**Subject: Rumford Falls Hydroelectric Project (FERC No. 2333-094)
Response to MDIFW Comments on the Final License Application**

Rumford Falls Hydro LLC's Responses to the Maine Department of Inland Fisheries and Wildlife's Comments on the Rumford Falls Hydroelectric Project (FERC No. 2333) Final License Application

Figure 3. HSC datasets for adult rainbow trout showing proposed binary HSC for suitable and optimal habitat.

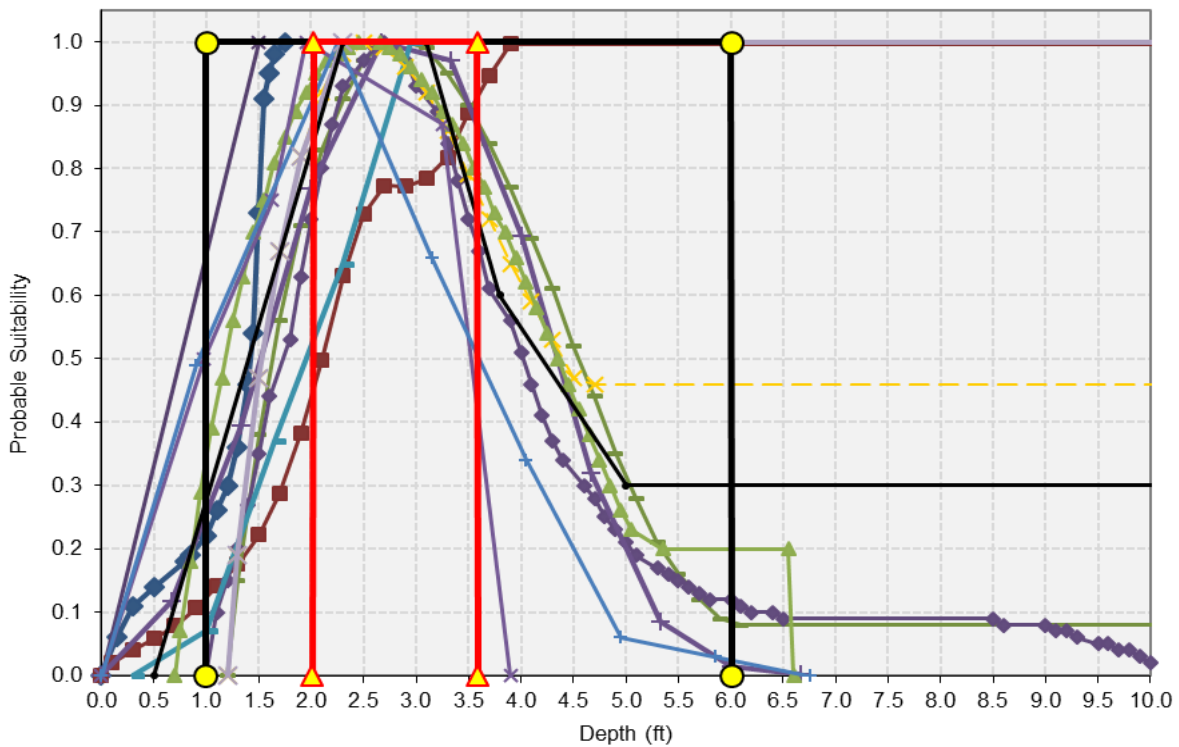
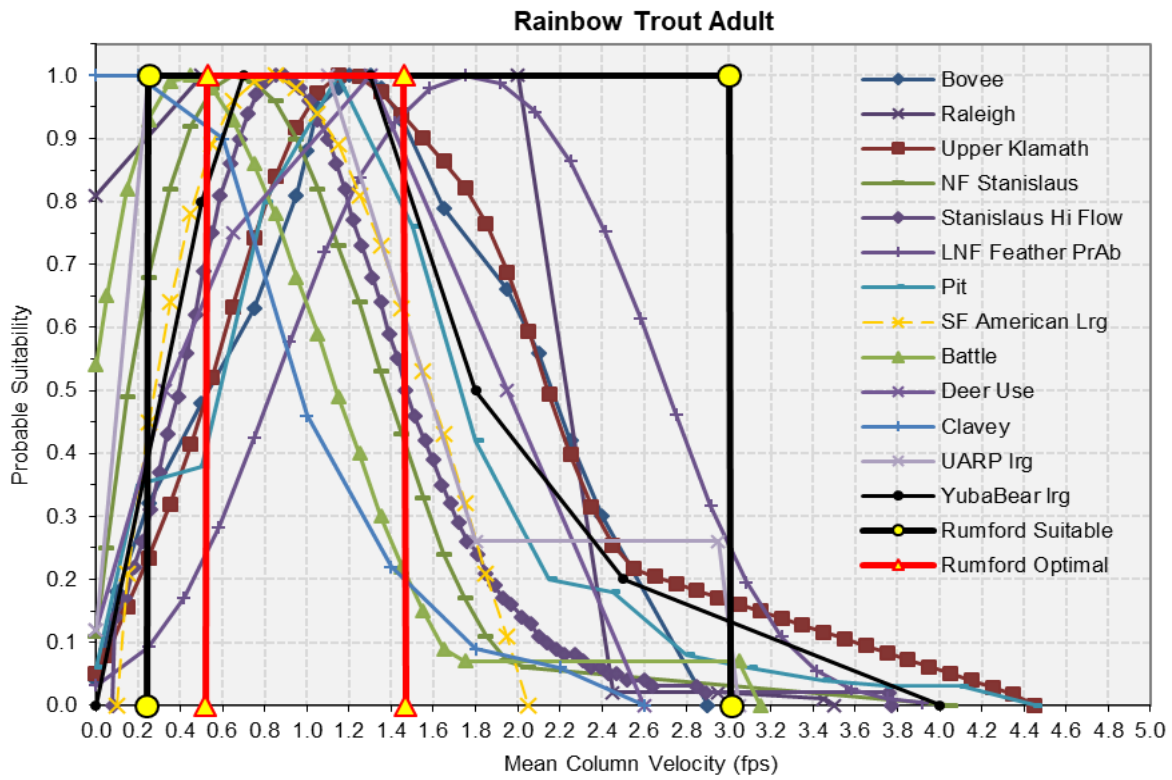
- HSI depth curve going to zero suitability at 6 feet may have some impact on the results and is not necessarily consistent with observations of adult trout behavior in large Maine river systems.

- No specific questions related to proposed binary HSC curves
- MDIFW reiterated their lack of support for the use of a binary approach, preferring to see a 1-D IFIM style analysis utilizing standard HSC criteria.

As detailed in response to MDIFW comment 3, the proposed habitat suitability criteria for this study were provided in written format on July 26, 2021, and were discussed at the August 24, 2021 site visit with MDIFW and MDEP staff. With the exception of the MDEP request to incorporate habitat suitability criteria for macroinvertebrates there were no comments provided on the criteria identified for adult smallmouth bass, rainbow trout, or brook trout. This was captured in the meeting notes (dated September 2, 2021) and was subsequently acknowledged by MDIFW (Attachment C).

MDIFW's criticism of utilizing HSC should have occurred during the study plan development during which RFH and MDIFW consulted with each other extensively as described above, not after the analysis when results may be contrary to MDIFW preconceived expectations (e.g., the MDIFW critique of the HSI depth curve for adult trout provided in their comments on the FLA [see MDIFW Comment 3 above]). Stating that flows should not be based on "suitable" habitat is unjustified and contrary to decades of instream flow analysis. PHABSIM, the hydraulic model used in the 1-D analysis (within the SEFA software), is the most commonly applied fish habitat model in North America (Annear et al. 2009)³. One of PHABSIMs ultimate products is the calculation of suitable habitat for target species and life-stages, based in part on the HSC which defines habitat suitability. The HSC in fact had conservative definitions on the range of suitable habitat, where curves for smallmouth bass, rainbow trout, and brown trout intentionally cut-off very shallow depths and slow velocities that many candidate HSC curves defined as suitable. MDIFW also rejected the truncation of deeper water for rainbow and brown trout based on "holding" habitat. Instream flow studies are primarily designed to assess feeding habitat, which for drift-feeding trout is typically in shallow to mid-depth, flowing water. This is in contrast to adult smallmouth bass, which are a roaming piscivorous predator that feed at a wide range of depths; hence the HSC keeps suitability at 1.0 into deep water. Deep, slow, holding habitat for trout might be applicable during winter when drift feeding is severely reduced and fish energetics results in shifts into calmer waters, but feeding habitat should be emphasized for drift-feeding salmonids.
